**PROJECT NO. AV08000087 FAA  
PHOENIX SKY HARBOR INTERNATIONAL AIRPORT  
TERMINAL 3 NORTH CONCOURSE 2 APRON  
DESIGN-BID-BUILD**

**ADDENDUM NO. 2**

ISSUE DATE: February 25, 2026

**1 AIRCRAFT-RATED PCC APRON PAVEMENT (P-501) DETAIL**  
SCALE: N.T.S.

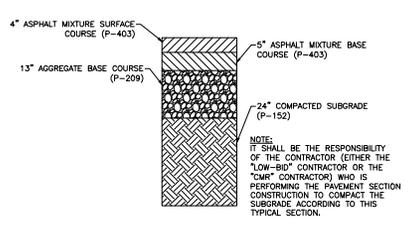
| Q4. | Typical Section 1 (aircraft – rated PCC apron pavement (P-501) detail) is showing a 6” P-403 Asphalt mixture stabilized base course as a single lift. If we do a 6” lift it will be extremely difficult to achieve a mat that is within the specified tolerance of 1/2”. Is there any room to change the spec over to allow two 3” lifts?   |

1. **SHEET B-C301** - [Replaces Sheet #19 of 42] Previously issued sheet but has been revised so that Detail #1 “Aircraft-Rated PCC Apron Pavement (P-501) Detail” more clearly states the lifts of the “Asphalt Mixture Section” (P-403), and the location of the Bituminous Tack Coat (P-603).

| A4. | <b>The intent of the proposed design (Typical Section 1) is not to do a single 6” lift, but two 3” lifts with a Bituminous Tack Coat (P-603) between the lifts. The Detail 1 on Sheet B-</b>  |

|     | <b>C301 will be updated accordingly for clarification and issued as part of an Addendum No.2.</b>   |
| A6. | <b>The Asphalt Mixture (P-403) will be constructed in two 3" lifts with a Bituminous Tack Coat (P-603) between the lifts. A Tack Coat will not be used between the Asphalt Mixture (P-403) and the Concrete Pavement (P-501) sections. The quantity of Bituminous Tack Coat (P-603) is correctly shown at a quantity of 12 tons.</b>  |

B-C405  
SHEET 38 OF 42

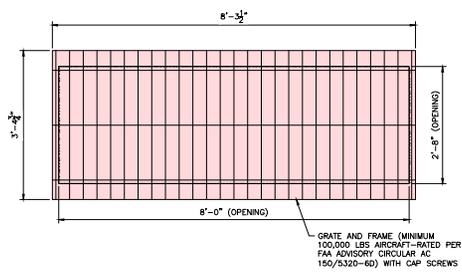
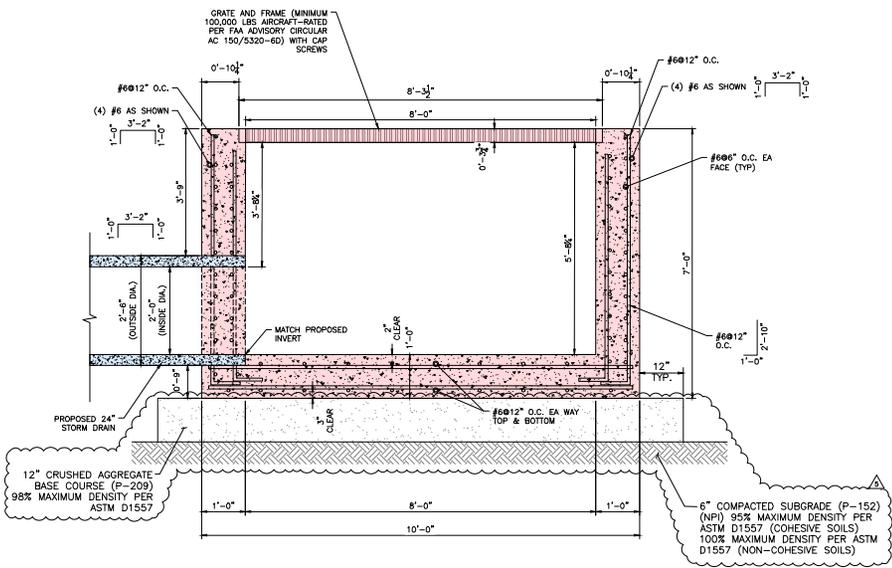
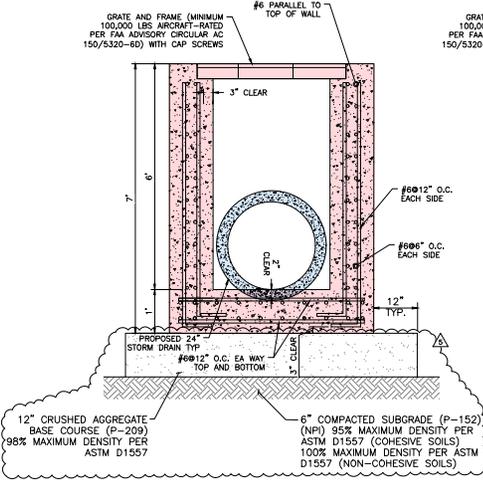
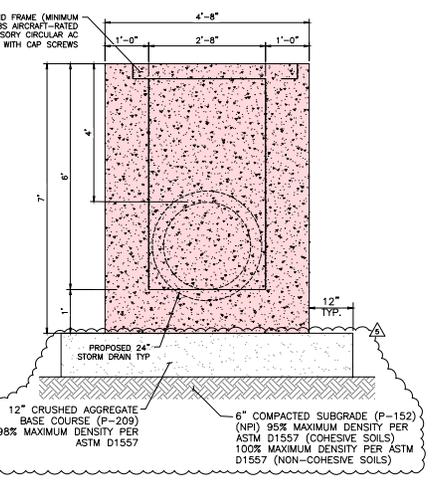
3. **SHEET B-C405** – [Replaces Sheet #38 of 42] Previously issued sheet but has been revised so that a 12" Aggregate Base Course (P-209)(NPI) and 6" Compacted Subgrade (P-152)(NPI) has been added to the Details of the Storm Drain Inlet. Also, the compressive strength of the structural concrete has been revised to be 5,000 psi (from 4,000 psi).

**B-C408**  
SHEET 41 OF 42

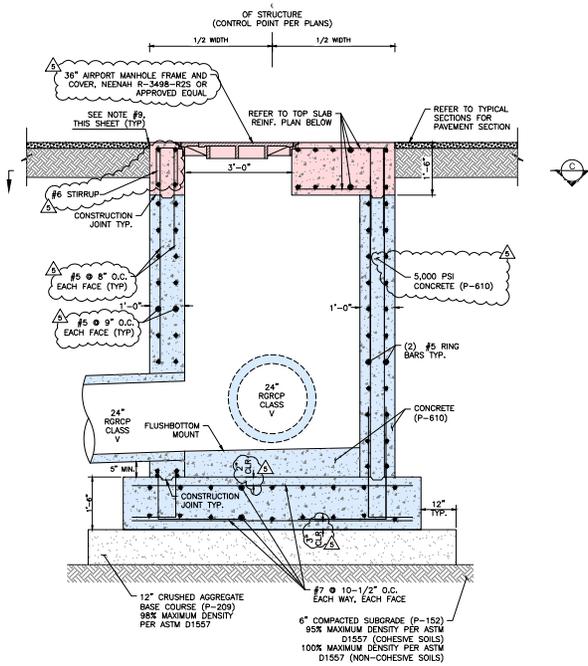
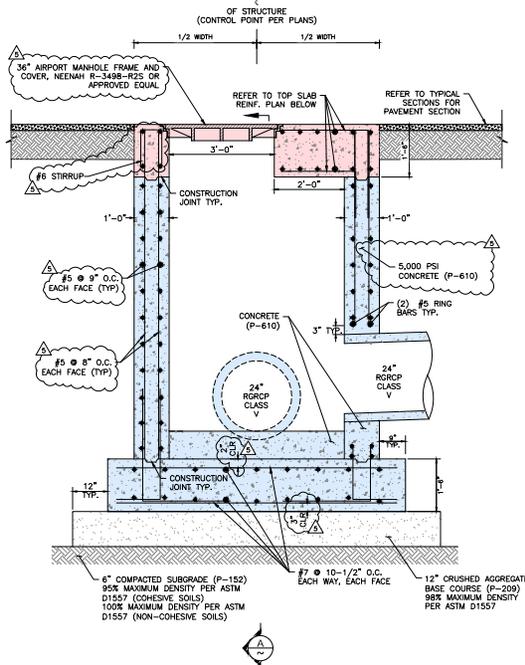
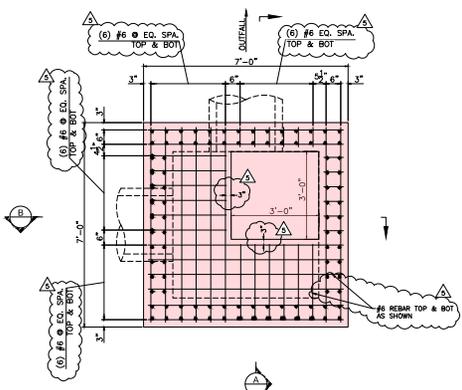
6. **SHEET B-C408** – [Replaces Sheet #41 of 42] Previously issued sheet but has been revised to add supplemental information to the rebar used in the proposed Storm Drain Manhole Structure and Lid. Also, the compressive strength of the structural concrete has been revised to be 5,000 psi (from 4,000 psi).
